**Addendum No. 1
BL162-23
Harris Elementary School Fire Flow Improvements**

The following addition/changes modify the Bid No. BL162-23 "Harris Elementary School Fire Flow Improvements" Contract Documents, dated November, 2023, as first advertised on November 08, 2023.

Harris Elementary School Fire Flow Improvements

BARGE
DESIGN SOLUTIONS

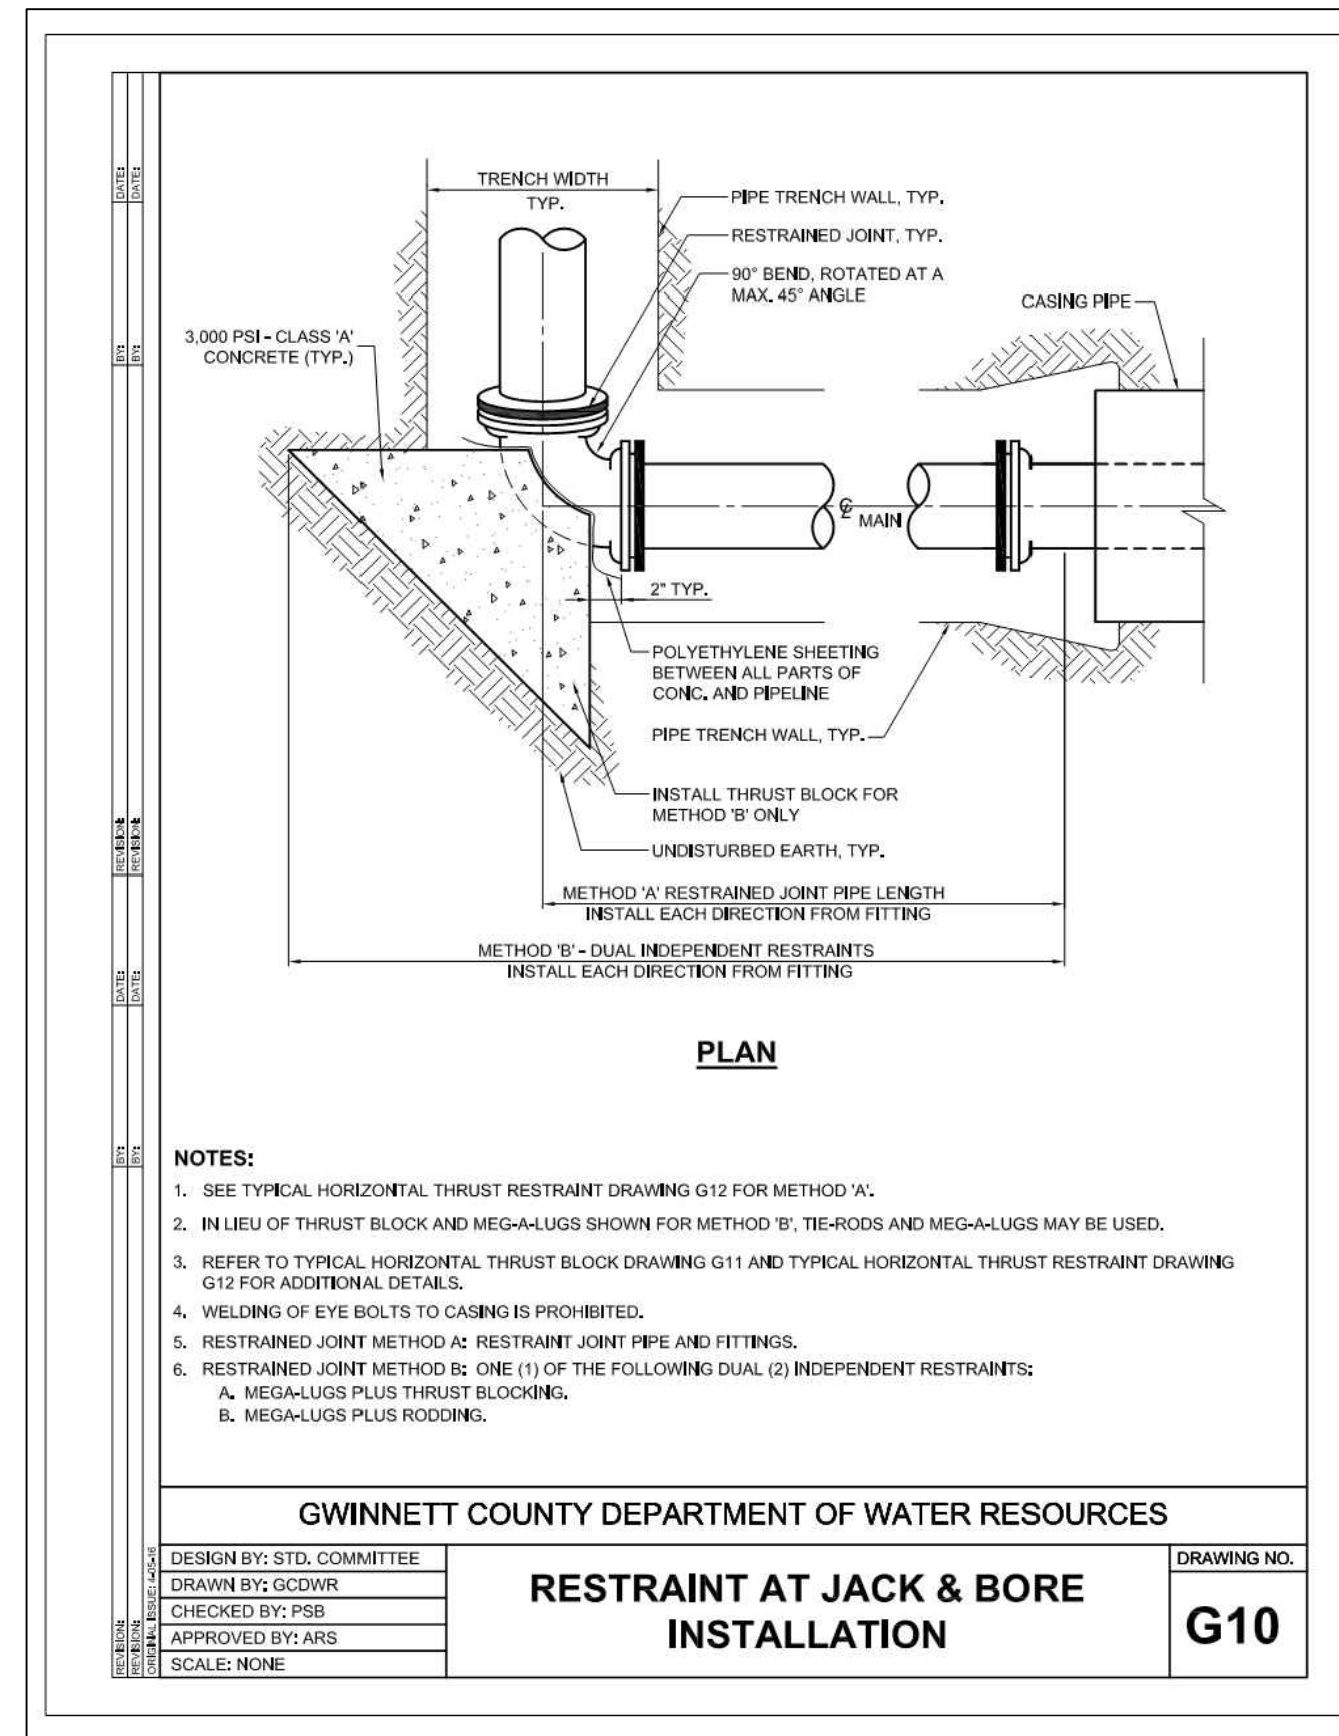
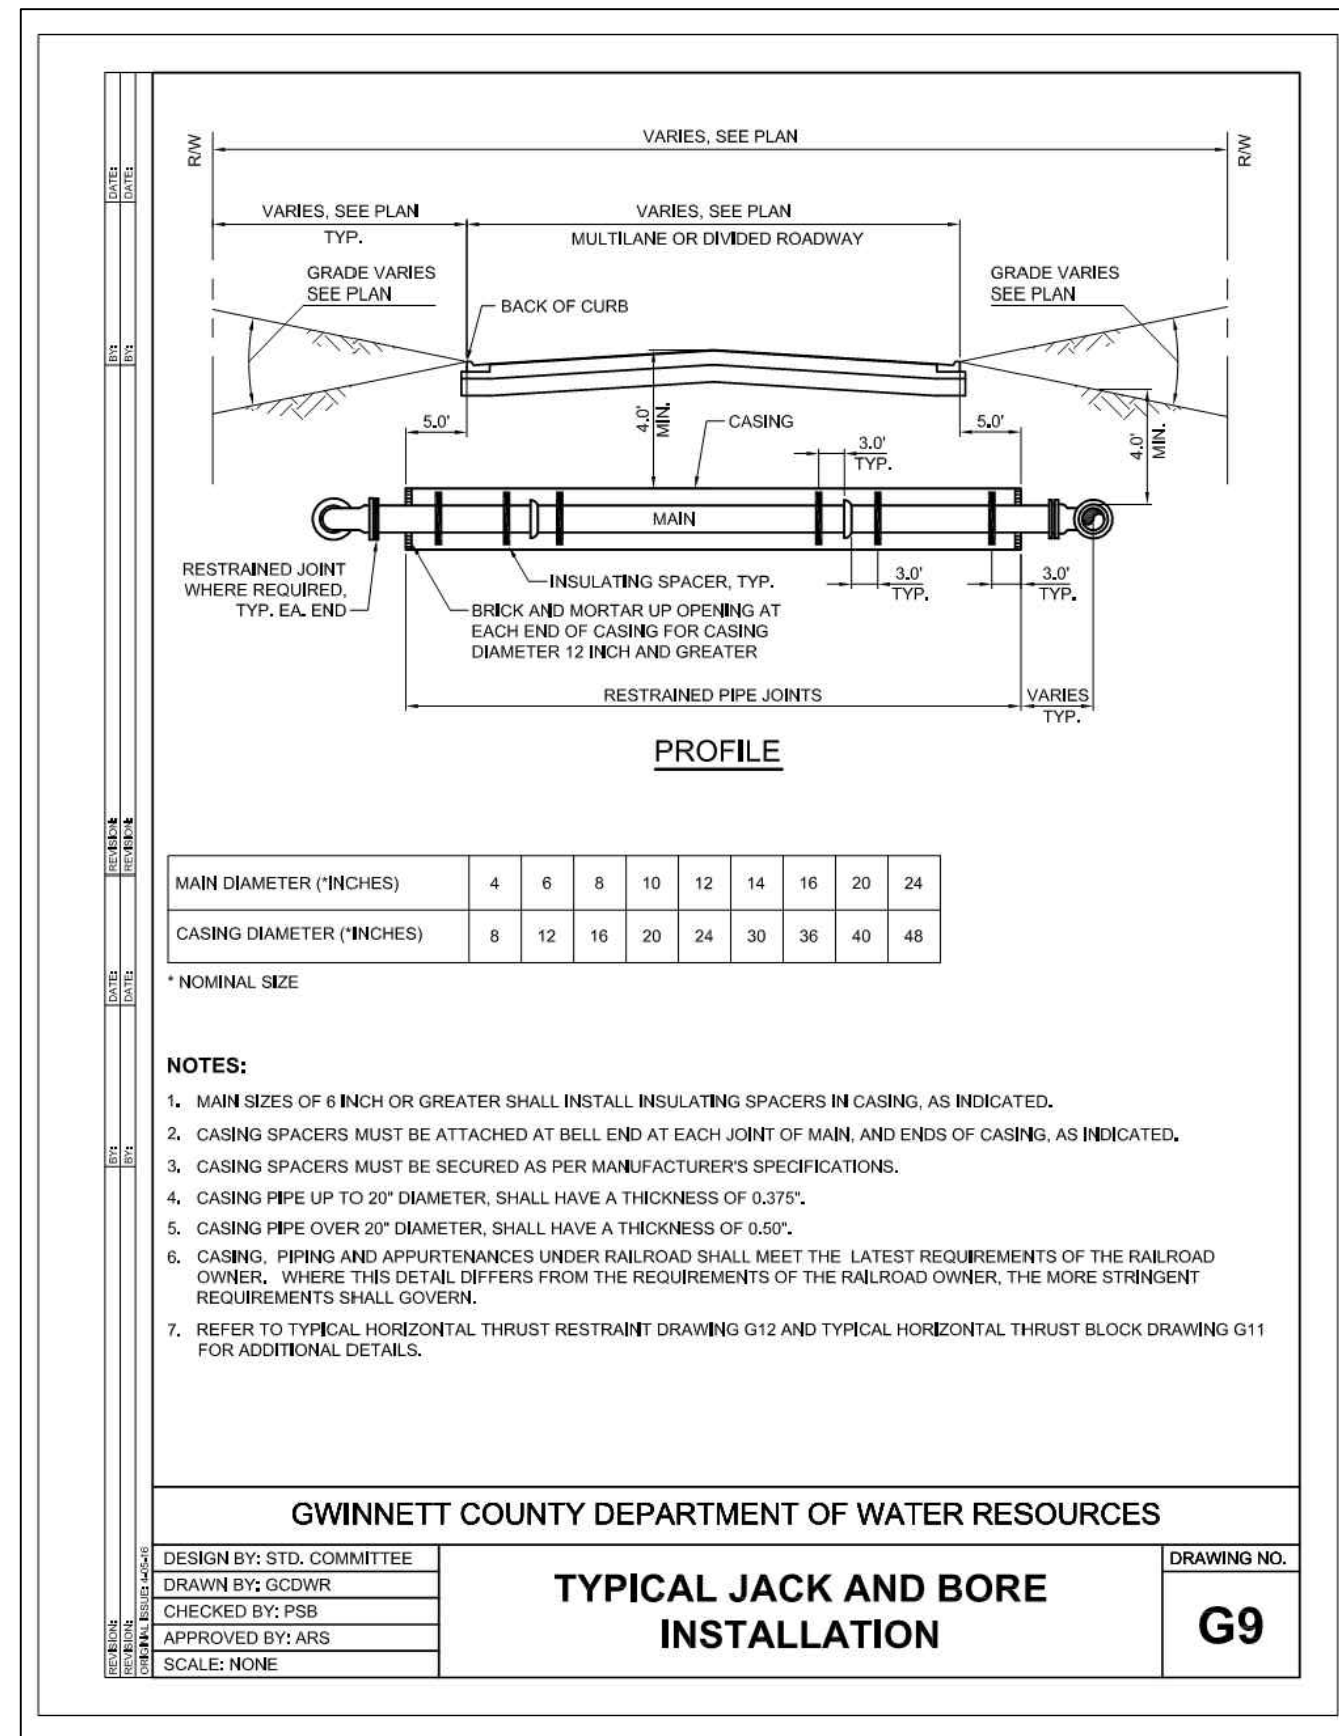
- Q12. Can a list of plan-holders be provided?
A12. The plan holders list is available at bidding.bargedesign.com.
- Q13. Sheet CD.01 shows a 16" insertion butterfly valve. Is this the 16" temporary line stop valve described in 33 12 16, 2.5 and Bid Item #35, or are we to quote a permanent insertion type valve per 33 12 16, 2.6?
A13. Provide insertion valve per Specification Section 33 12 16 Paragraph 2.6.

3. Drawing CD.01, Detail D1/C1.05 Titled "Duluth Hwy and Bunten Road"
ADD the following Note 1: "The Contractor shall pressure test against the 16" tapping valve at the connection to the existing 16" CIP water main. The 16" Insertion valve shall be installed to limit the impacts of the shutdown when the adjacent cut and plug is performed but shall not be tested against".
